# UNITED STATES PATENT AND TRADEMARK OFFICE

APPLICATION NO.	FILING DATE	FIRST NAMED INVENTOR	ATTORNEY DOCKET NO.	CONFIRMATION NO.
09/321,633	05/28/1999	JAMES W. KENNEY	E-1901	6762

**Office Action Summary**

## DETAILED ACTION

FIG. 20

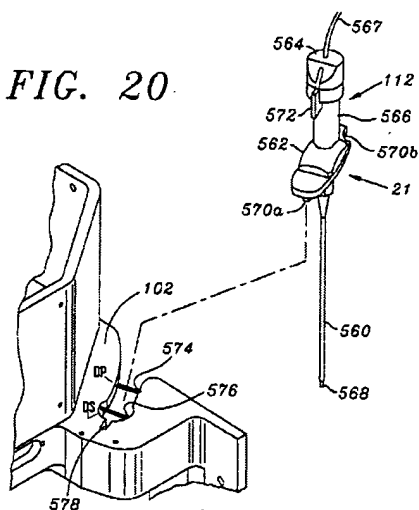
Additionally, this switch, through the microprocessor 43, automatically activates/deactivates the air pressure source. Kenney fails to teach a gun holster arranged to support the gun above the worktable. Goodale *et al* teach a pipette holster used to support the pipette 112 above a work table in a vertical direction. Goodale *et al* teach a mounting bracket 102 having a fork with prongs 574 and a circular socket 576 constructed to removably hold the pipette. Wherein the socket is formed between the prong and has a diameter (DS) which is larger than the distance between the prongs (DP), (column 11, line 61- column 12, line 28, and modified Fig. 20 below.) Such use of a bracket insures that the pipette tube does not touch anything and will remain sterile.
